## **2018 Clarifications**

**Issued March 9, 2018**

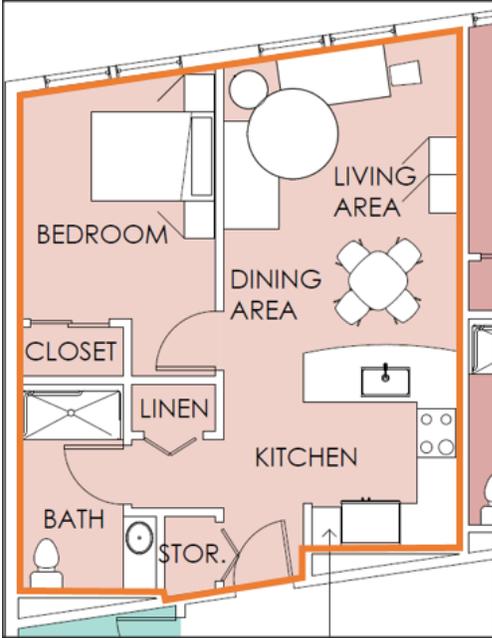
With regard to the definition of "Residential Floor Area", when ADOH says "paint to paint of the interior of the perimeter walls" are they counting interior walls in the units as part of the residential floor area?

*Yes. Residential Floor Area "means the total net square footage of the floor space in all Units (measured from paint to paint of the interior of the perimeter walls) including closets within the Units and balconies (to the exterior edge of any railing) attached to the Units for the sole use of the tenants occupying the Units."*

*In the example to the left, all of the area within the darker orange line is included in the Residential Floor Area.*
